Product Change Notice

PCN Ref Nº: New housing design for the PT10 and PTC10 series.

Current design

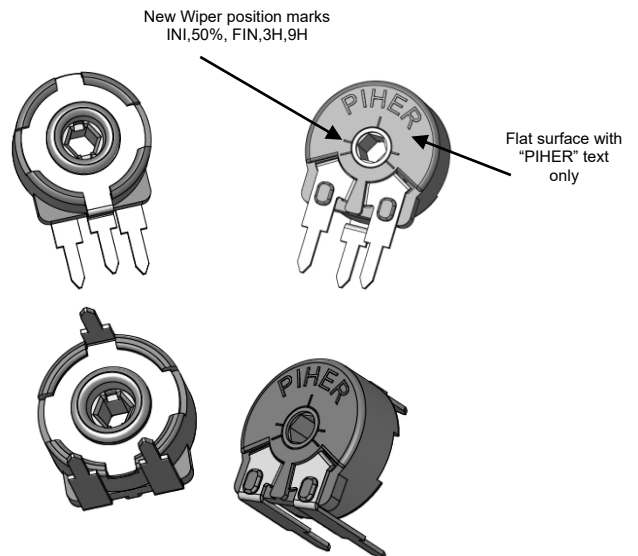
Please be advised that we are upgrading the housing design for the PT10 AND PTC10 potentiometer series. This change is *backward compatible* with the current tooling design and it is including rotor position marks in the front and having a flat front surface with "PIHER" text instead of "PIHER SPAIN". Mechanical and electrical specifications remain unchanged. This change will be effective starting April 1st, 2021.
